Docket Item # 9
BAR CASE # 2009-0015

BAR Meeting
March 4, 2009

ISSUE: Demolition/Encapsulation
APPLICANT: Patrick Camus for Ken and Esther Carpi
LOCATION: 117 South Lee Street
ZONE: RM/Residential

BAR CASE #2009-0015, 0016, 0017 3/4/2009

Figure 7. Proposed demolition in elevation.

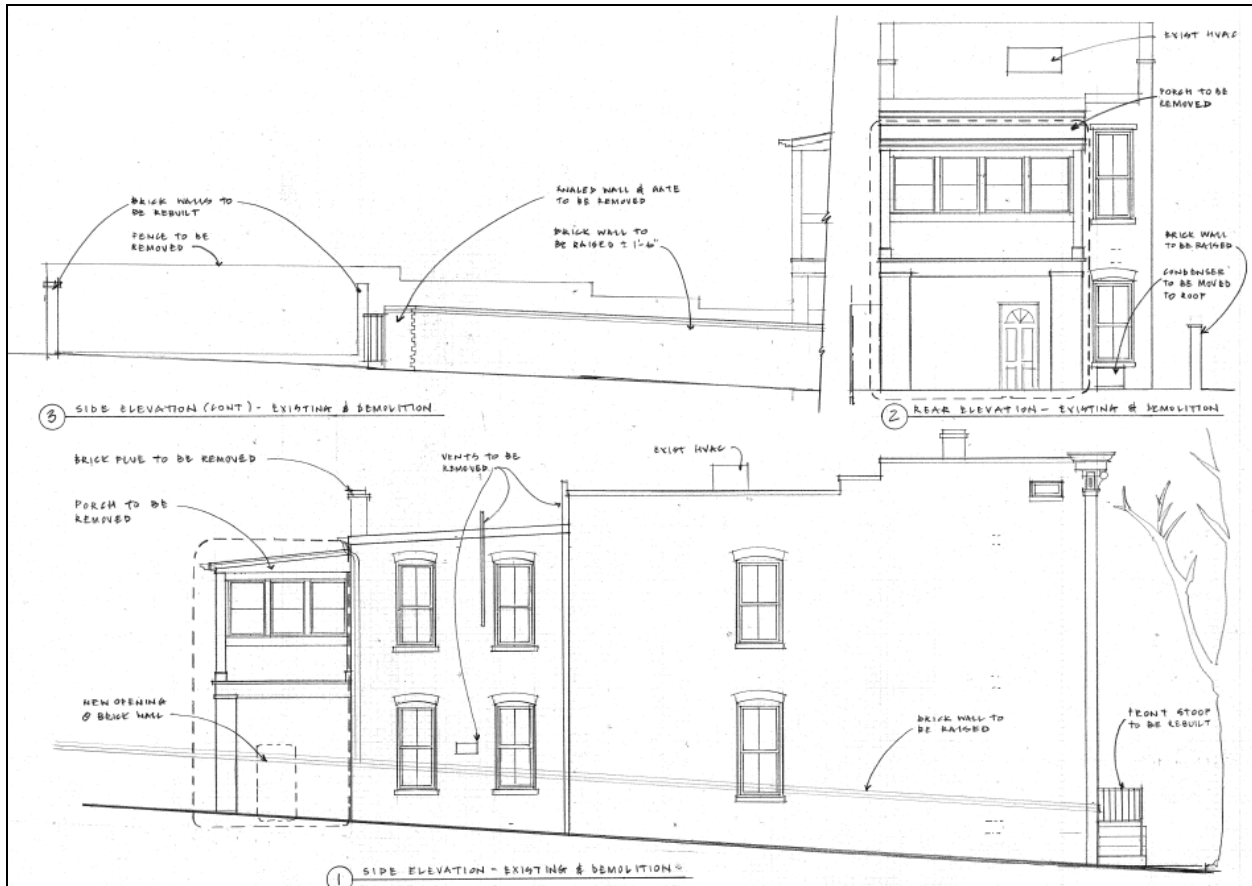
In the opinion of Staff, the above criteria are generally not met. Staff finds that the proposed area for demolition/encapsulation is predominantly limited to the rear elevation, and has previously been encapsulated. Staff finds that although the existing two-story rear porch addition likely dates from at least 1941, the addition has been so significantly altered and rebuilt over the years that it has lost its historic integrity. Furthermore, the historic townhouse will maintain its integrity and the existing rear ell form will be continued with the proposed addition.

Regarding the demolition of the brick flue, the *Design Guidelines* indicate that “existing chimneys should be maintained *in situ* and not removed without a compelling reason and substantial justification.” The applicant has not provided a compelling reason for demolition of the chimney/flue. While the flue is not original to the building, Staff finds that it possibly is still considered historic (50 years or older) and should be retained as part of the evolution of the building, in conformance with the *Guidelines*.

Staff recommends deferral of the Permit to Demolish/Encapsulate.

Figure 8. Proposed demolition in plan.

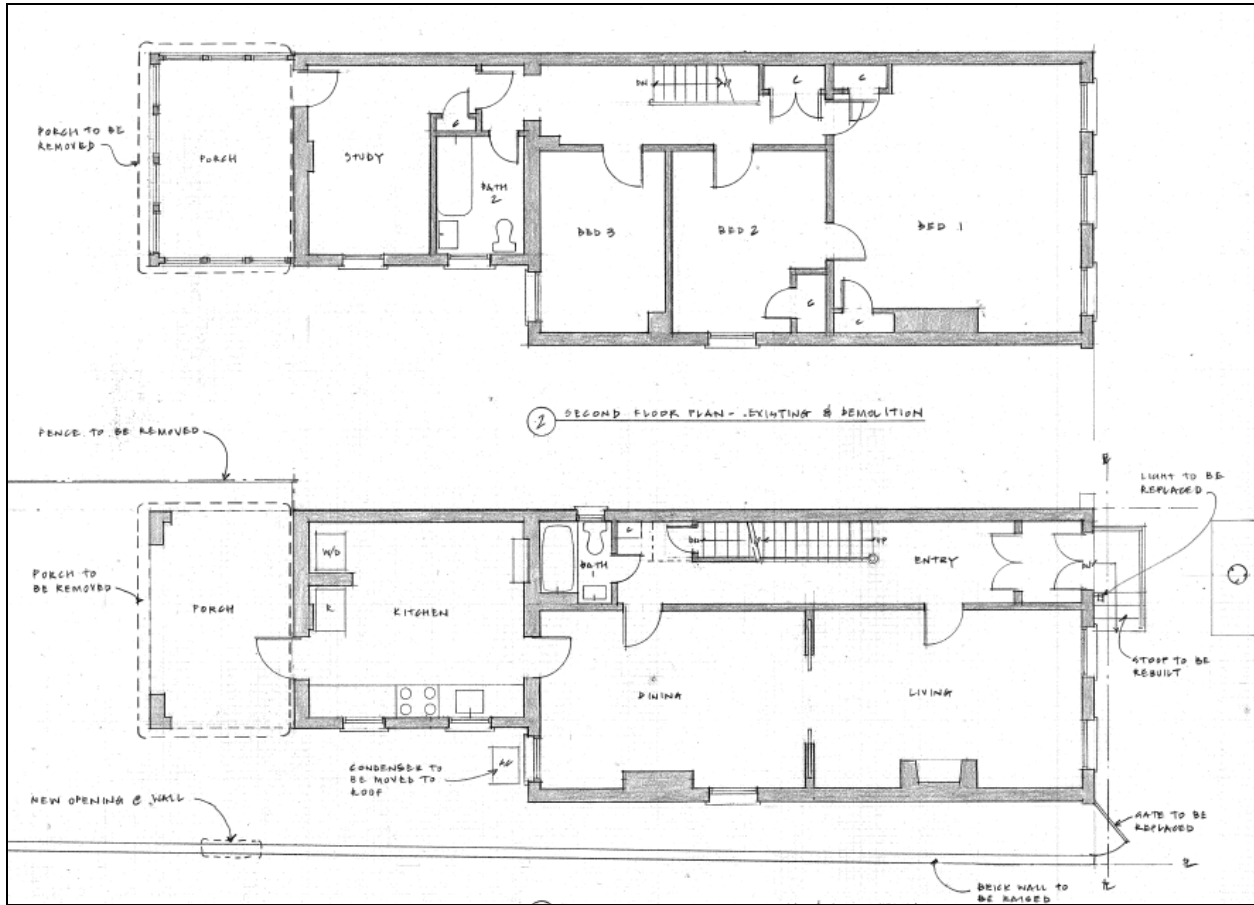
While Staff has no objection to the demolition of the non-historic brick wall adjacent to the parking area or the dilapidated wood fence, Staff is concerned about the proposed demolition of the historic wall on the alley elevation. Staff finds that Criteria 5 and 6 are applicable in this circumstance. The wall on the south property line along the alley is a historic wall with a distinctive decorative coursing at its top. Staff finds that the retention of this wall, in its current form (without added height or the removal of a portion for a new gate) helps preserve and protect an historic place and area of interest (the viewsheds from both South Lee and South Fairfax streets, as well as a historic alley) as well as promotes the general welfare. The brick wall at the rear (west) property line also appears to be historic yet has been significantly altered and patched (with CMU in one part) that it does not retain its integrity. Staff notes that this wall does have some historic brick and advises that the historic brick should be retained and reused on the site.
